# Access Compliance Report

## Public Rights-of-Way

### (Curb Ramps)

Intersection ID: 2755	Main Street: BELL'S_MILL_DR	Cross Street: RIDGEFIELD_DR	Location:	N
ADA ID: 2EDBDDDB0F311	Ramp Type: Perp	Initial Pass/Fail: Fail	Overall Compliance: No	Severity Score: 22.5

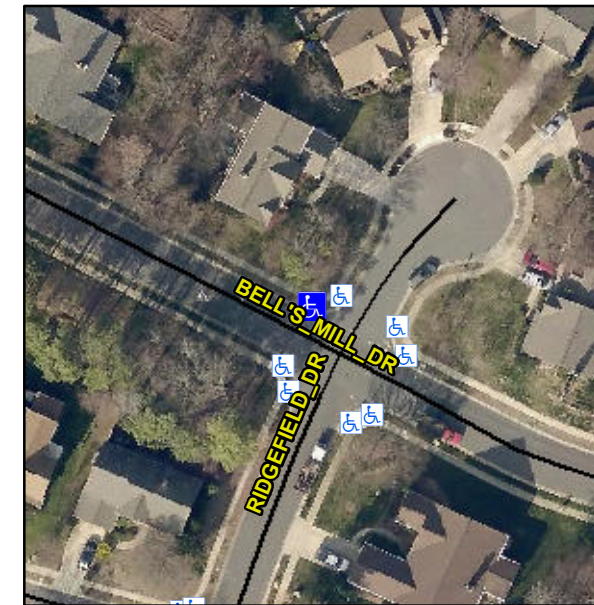
**R304.5.1, R304.2.2, R304.5.3**

Compliance	Description	Data	Compliance	Description	Data
N/A	Ramp Length (in)	49.0	No	Ramp Slope (%)	8.4
No	Ramp Width (in)	38.0	No	Ramp XSlope (%)	3.8
N/A	Flare Type LT	N/A	N/A	Flare Type RT	N/A
N/A	Flare Slope LT (%)	N/A	N/A	Flare Slope RT (%)	N/A
N/A	Flare Traversable LT?	N/A	N/A	Flare Traversable RT?	N/A
N/A	Landing Length (in)	N/A	N/A	DWS Provided?	N/A
N/A	Landing Width (in)	N/A	N/A	DWS Contrast?	N/A
N/A	Landing Slope (%)	N/A	N/A	DWS Length (in)	N/A
N/A	Landing X Slope (%)	N/A	N/A	DWS Full Width?	N/A
N/A	Landing Curb? (Y/N)	N/A	N/A	DWS Offset (in)	N/A
N/A	Shared Landing?	N/A			
N/A	Gutter Ponding?	N/A	N/A	Gutter Slope (%)	N/A
N/A	Gutter Lip Ht (in)	N/A	N/A	Gutter X Slope (%)	N/A
N/A	Painted X Walk1?	No	N/A	Painted X Walk2?	N/A
	X Walk 1 Direction	To SW		X Walk 2 Direction	N/A
N/A	X Walk 1 Width (in)	N/A	N/A	X Walk 2 Width (in)	N/A
	X Walk 1 Slope (%)	1.8		X Walk 2 Slope (%)	N/A
	X Walk 1 X Slope (%)	3.0		X Walk 2 X Slope (%)	N/A

**Remove & Replace Entire Ramp.**
